CITY OF WEST LAKE HILLS, TEXAS
NOTICE OF BOARD OF ADJUSTMENT (BOA) REGULAR MEETING
Wednesday, September 11, 2024 at 7:00 PM

3. **Administration** Discuss and consider approval of the August 14, 2024 Regular Meeting Minutes.
4. **Public Hearing 3663 Bee Cave Rd Suite 4-A** – Discuss and consider action to approve Ordinance 157-2024-D for a Special Use Permit request to allow the sale of beer and wine beverages in a restaurant for on-premise and off-premise consumption on a property Zoned B-2 Business 2 District (West Lake Hills Code, Section 38.04.031). Applicant: Westlake Swedish, LLC (Swedish Hill).

5. **Land Use 200 Wildcat Hollow**: Discuss and consider action to allow for 25-foot encroachment for the building and grading for structures into a 50-foot front setback adjacent

6. **Land Use 1501 Wildcat Hollow:** Discuss and consider action on the proposed variances:

Scenario 2 – Presented to ZAPCO 25-foot encroachment on Skyline

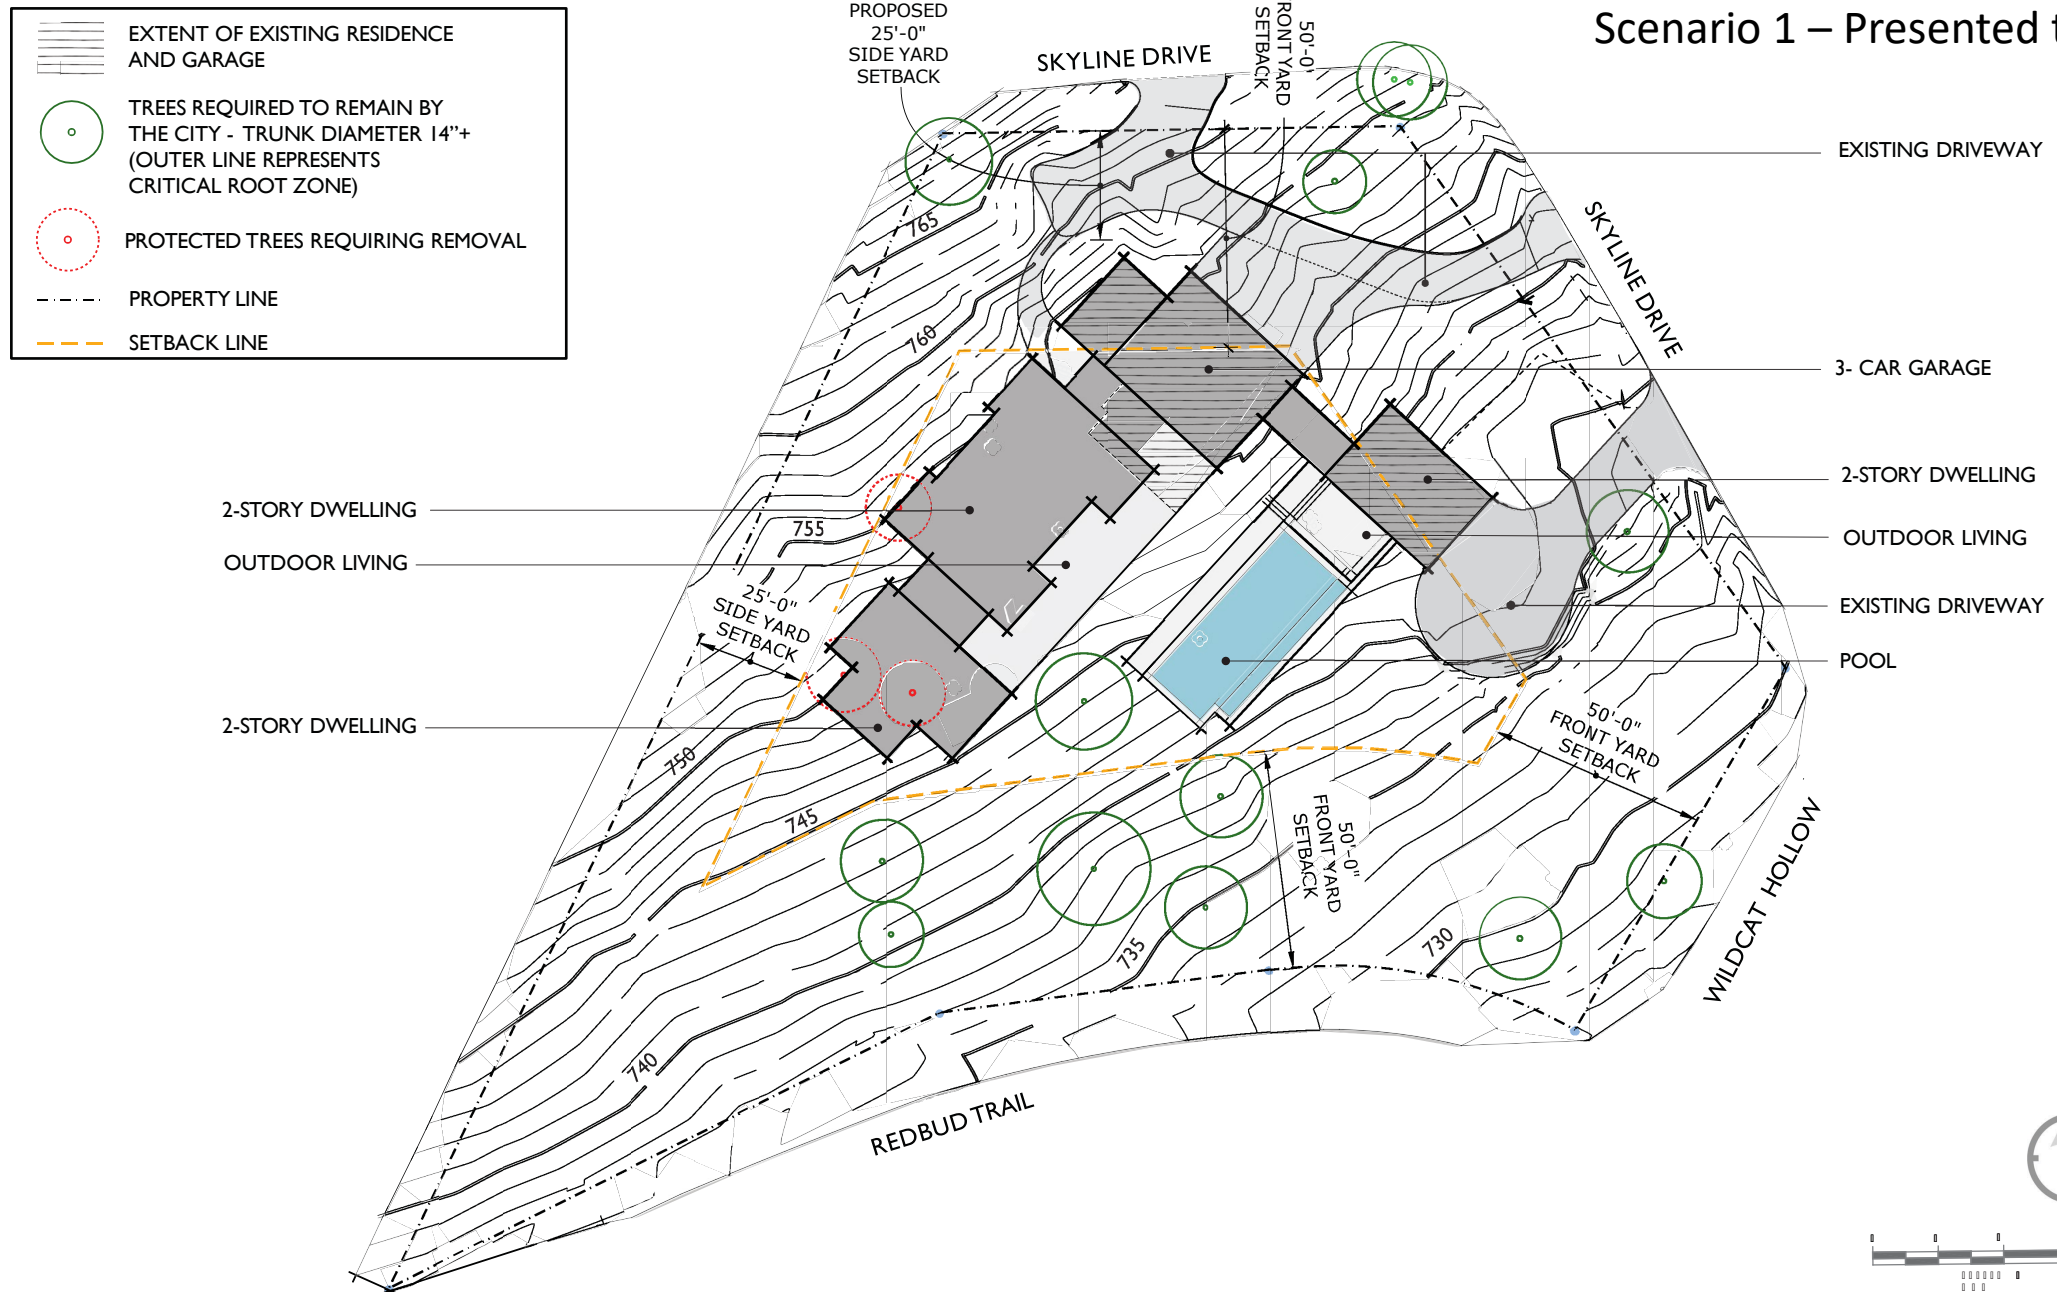
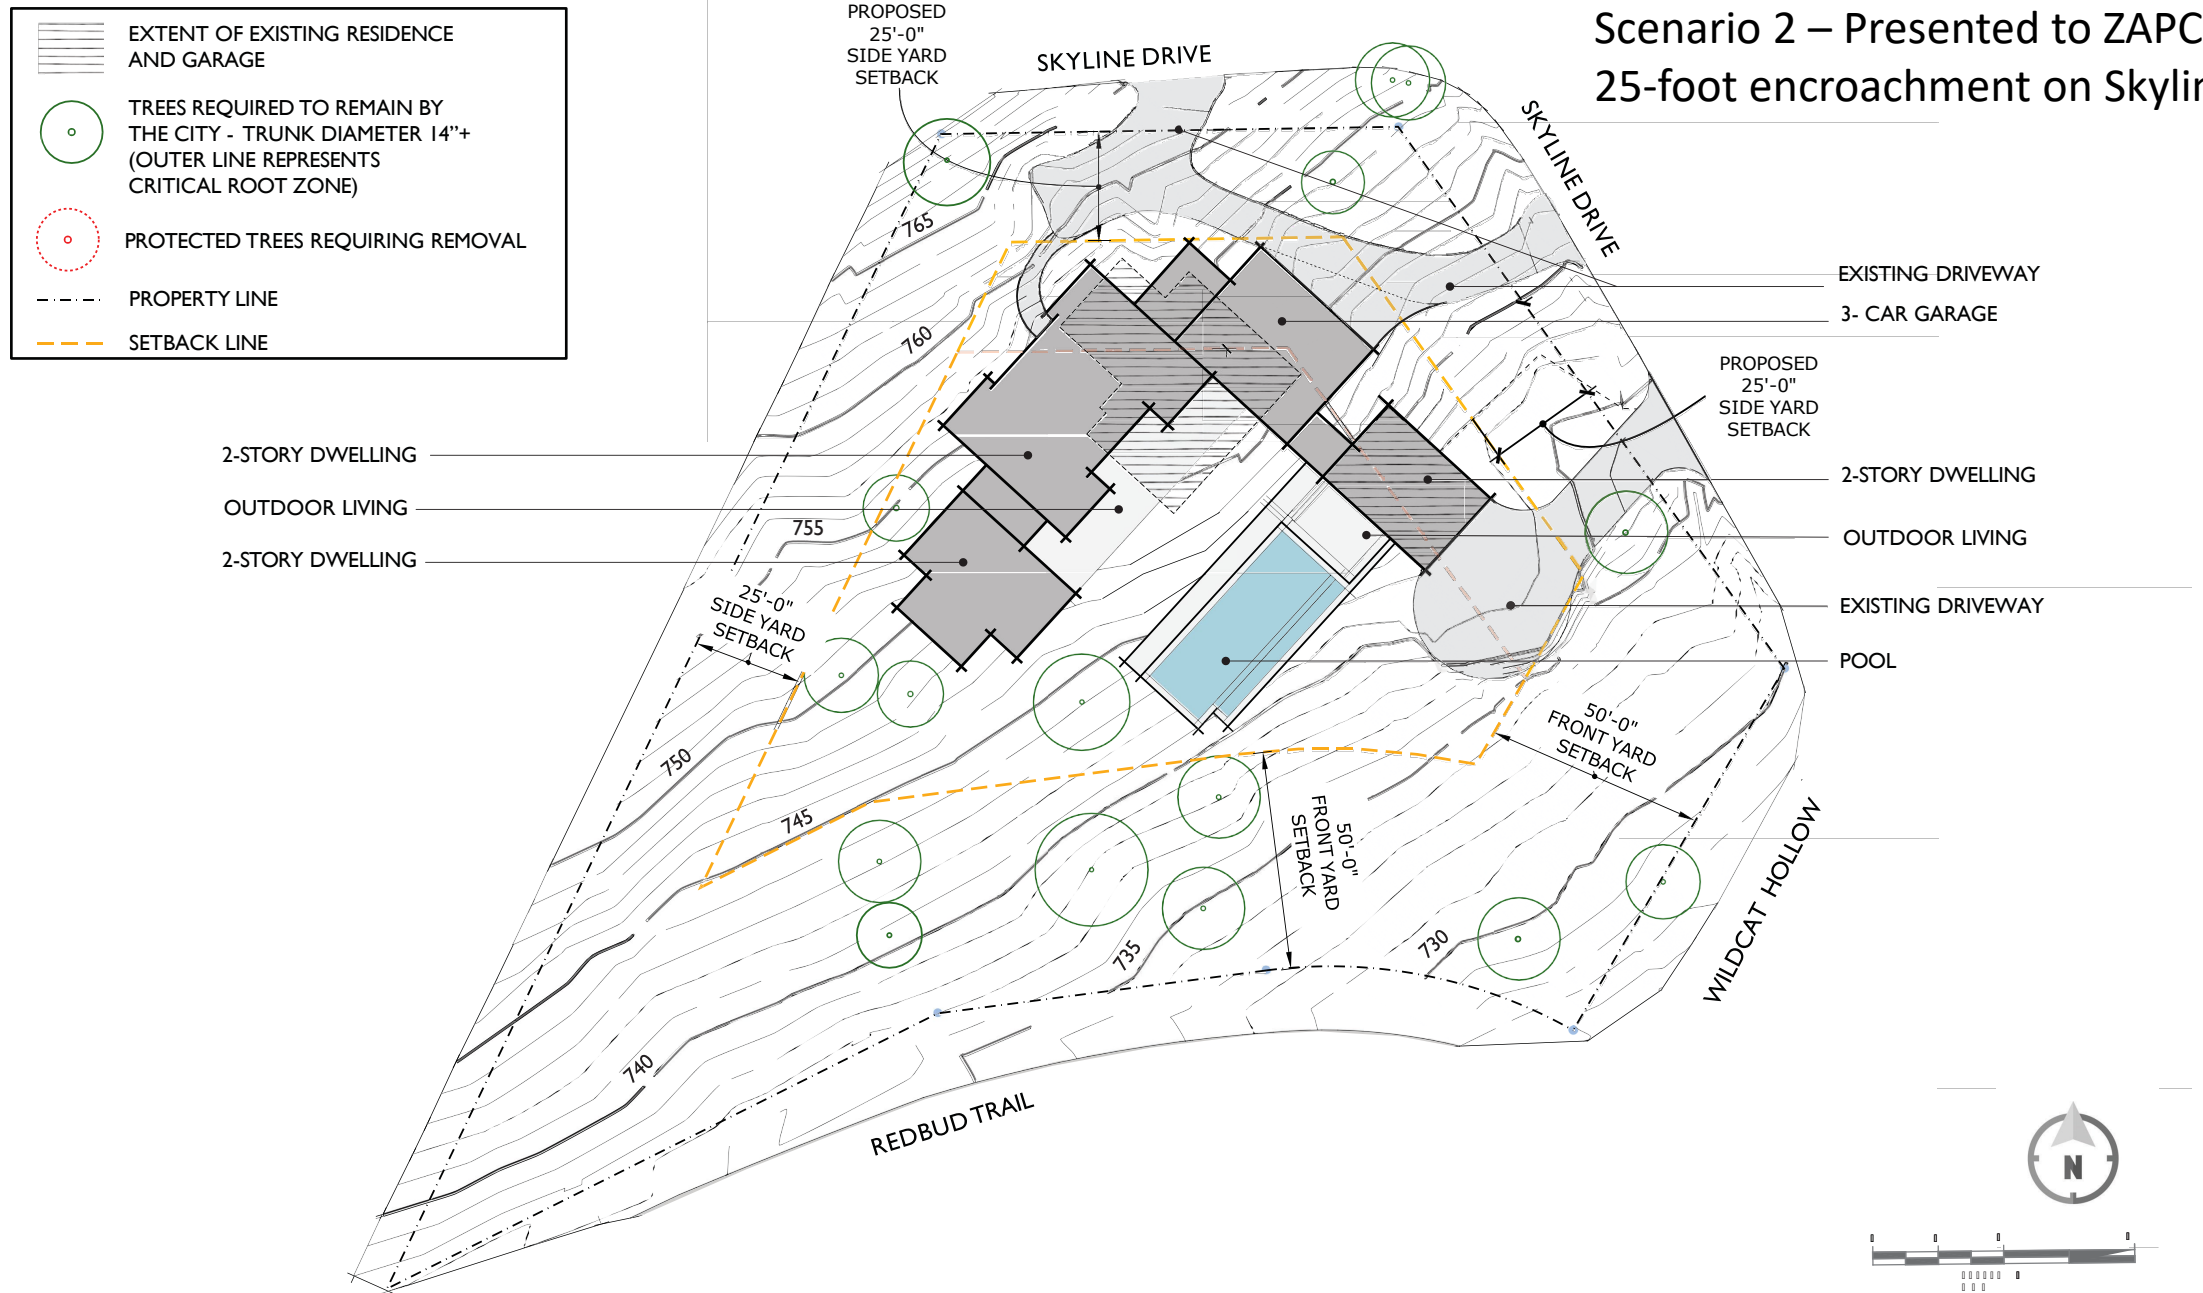
- Staff recommends approval of the variance request based on the staff findings of fact in Exhibit B, with the following conditions:
 - 25- foot encroachment into the northwest portion of Skyline
 - 20-foot encroachment into the northeast portion of Skyline
- Public Comment:
 - One written comment has been received in support.

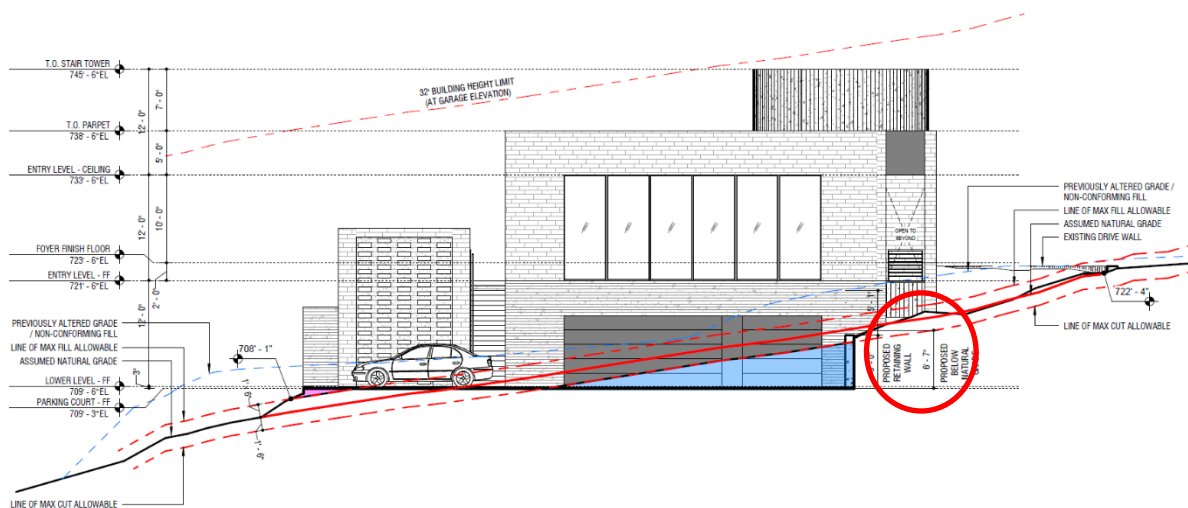
On the uphill slope, they are proposing more than 18 inches of cut (up to six feet), and on the down slope, they are proposing more than 18 inches of fill (up to six feet). The proposed area is indicated to have 0% slope. Some of the excess grading could be limited with a partial match of the existing slope. The drive court area size could also be reduced, considering that they are also asking for the existing circle drive that provides additional parking to remain.

2. Allow a retaining wall up to 6'7" in height above natural grade, where the maximum wall height anywhere on the site is 6 feet. (Section 22.03.170);

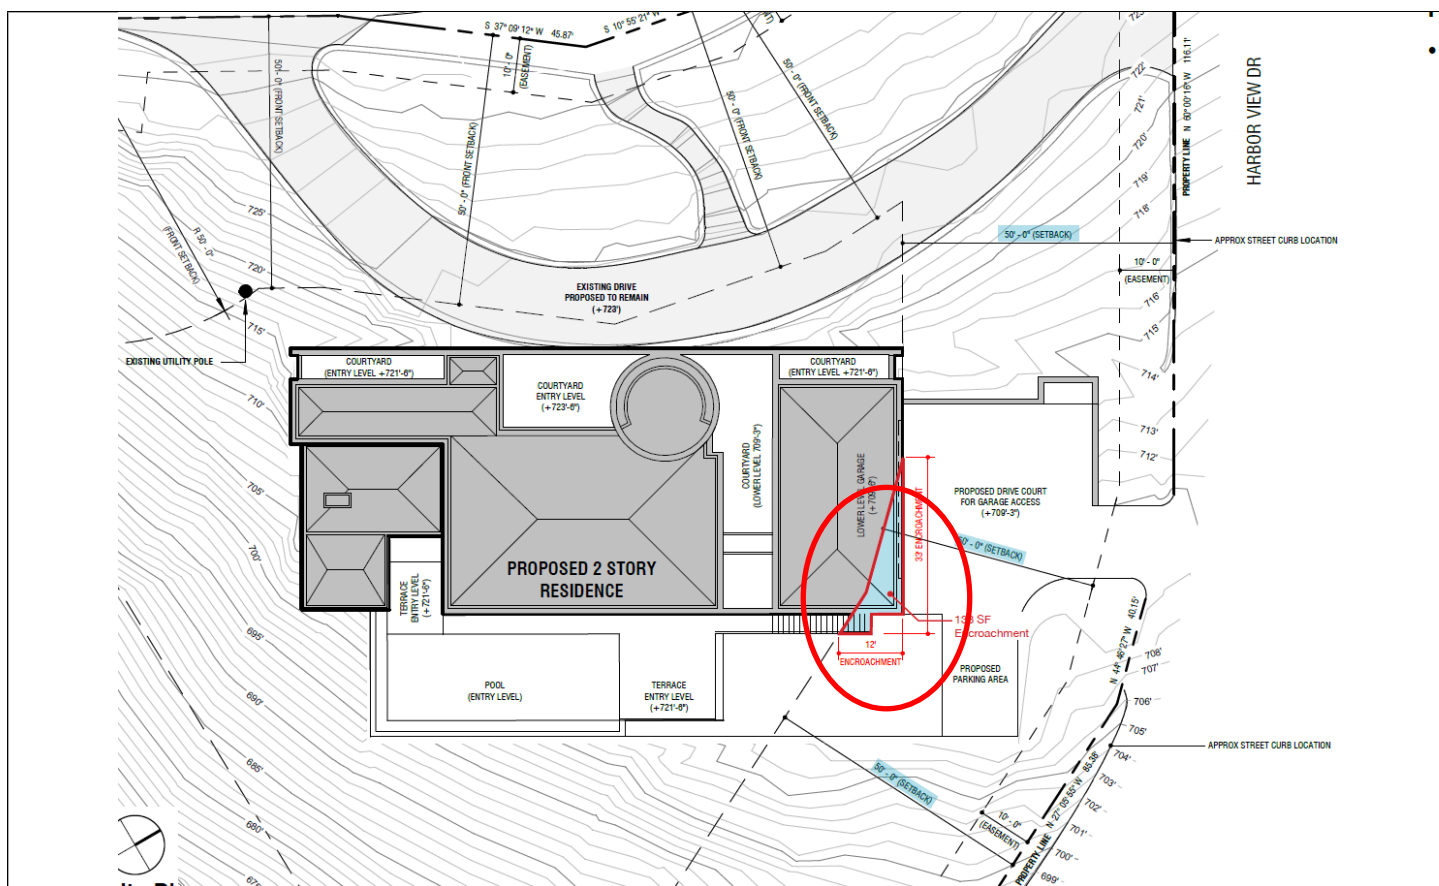
This variance request goes along with the first variance request. Determining the "natural grade" on an already disturbed site is difficult. They have estimated the original grade (solid red line) and that the grade cut from that point is 6 feet 7 inches.

The house location appears to be driven by centering the house on the existing circle drive. Shifting the house to the west or shifting the orientation may alleviate the need for the encroachment.

1. Allow up to 6 feet of grading in the 50-foot Harbor View Drive front setback for the garage access/drive court where grading greater than 18" is not allowed.

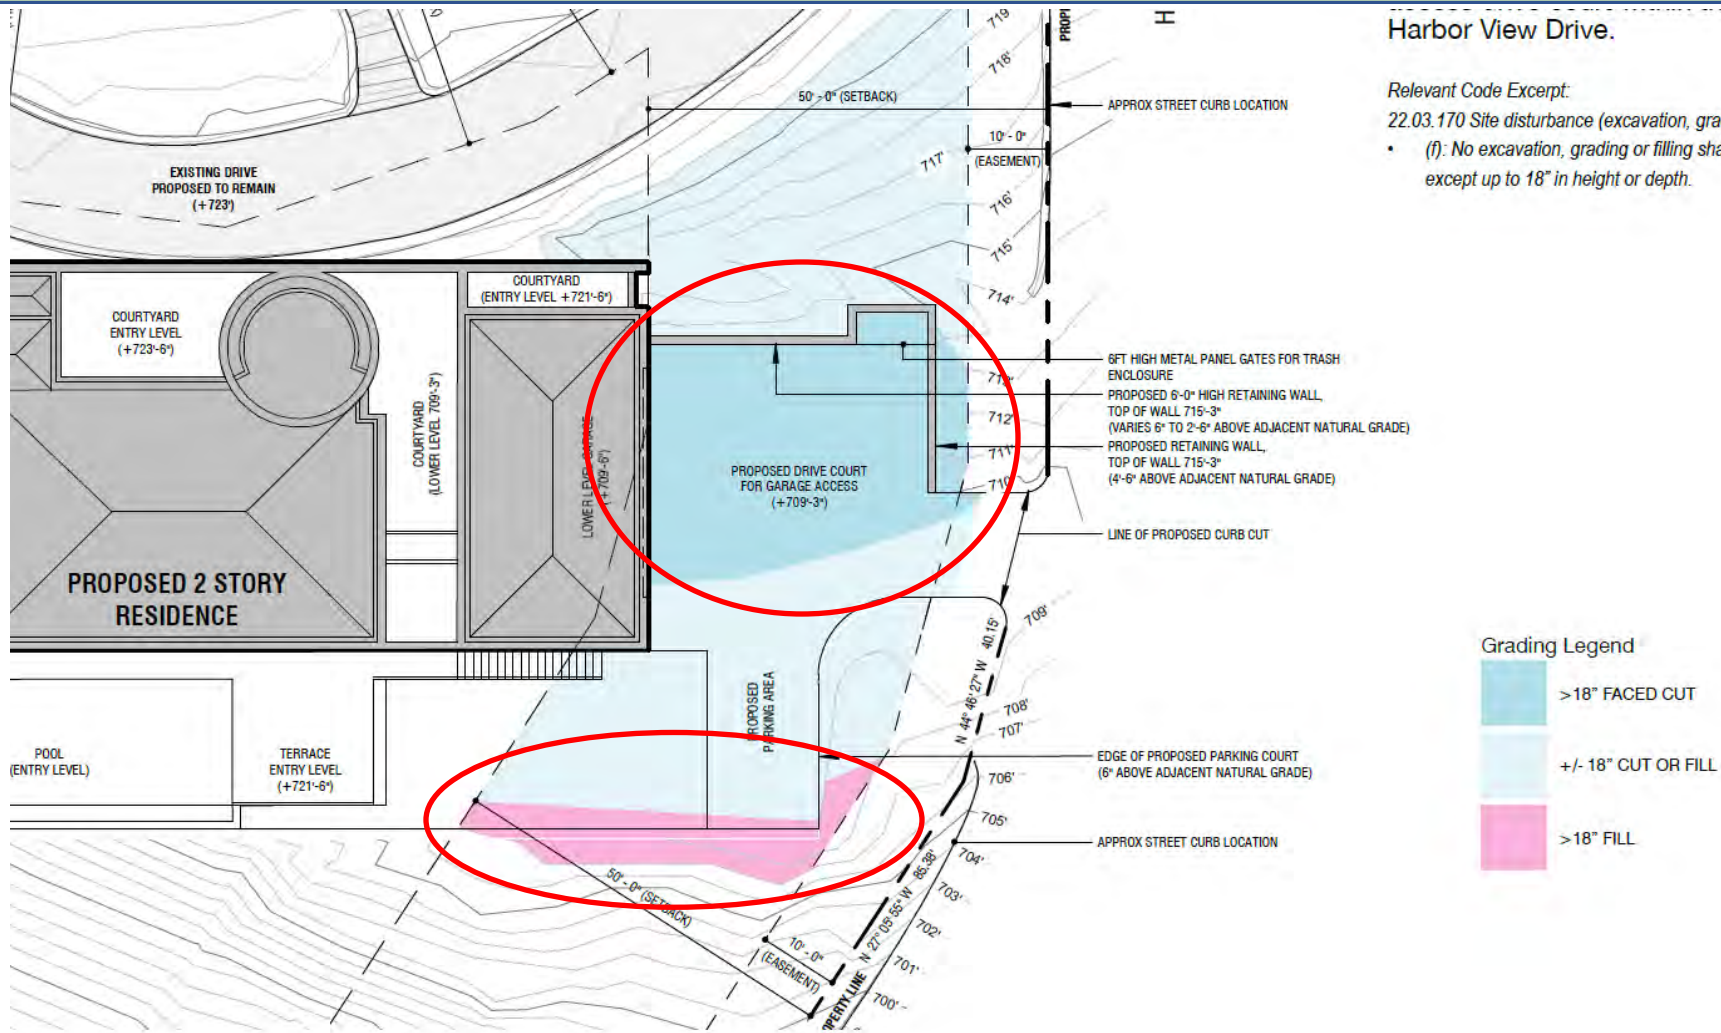
The city engineering team has provided analysis and recommends denial of all variances. They also recommend that the applicant provide additional analysis on the grading for the house, as additional variances might be needed from the Drainage & Erosion Control Manual cut and fill limits (Attachment 5).

Based on the information received and the extents of which existing trees that are proposed to be removed or saved is unknown - we cannot support the requested variances at this time. We recommend revising the exhibits to show the surveyed topography with respect to an estimated proposed grade with retaining walls, along with the existing trees to determine any impact to the trees. Per the city code of ordinances, tree mitigation and/or preservation should be considered with respect to overall site grading. Due to the natural topography of the site, we believe that the applicant will also need a variance to the allowable cut/fill on the site per the Drainage Manual (Chapter 7) and should be considered.

2. Allow a retaining wall up to 6'7" in height above natural grade, where the maximum wall height anywhere on the site is 6 feet

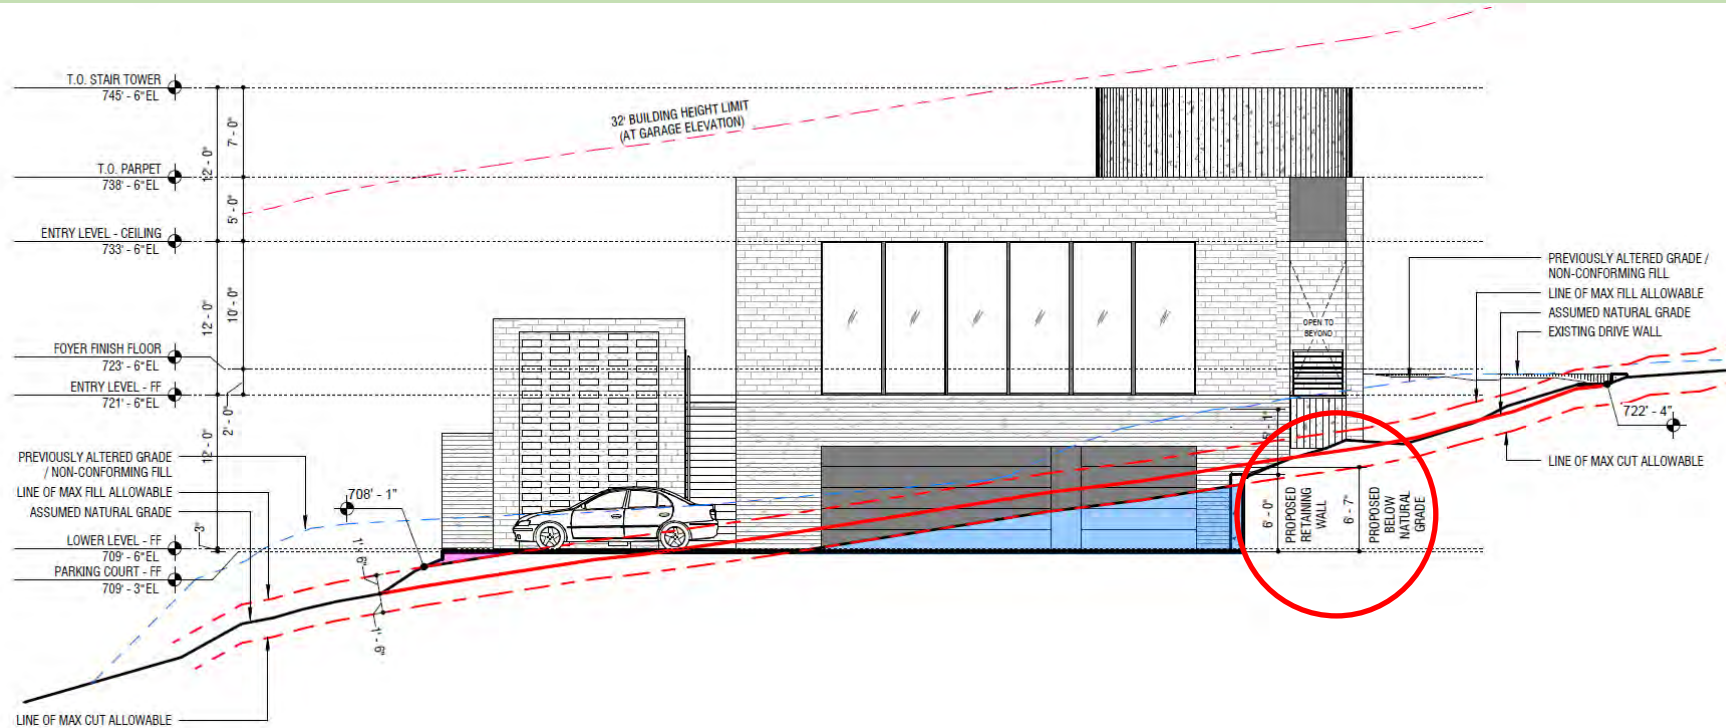
- 2. Allow 6'7" retaining wall from line of assumed natural grade.
 - a. **Assumed natural grade is not an item which is taken into account when reviewing grading plans. Only natural grade, which is the existing grade as documented by a licensed surveyor, should be compared to proposed grade. The engineering team cannot support this request given the proposed wall height exceeds allowable open cut (Ch. 7 Drainage Manual) and the walls are located within the setback where 18" of maximum grade change is allowed per the city code of ordinances.**
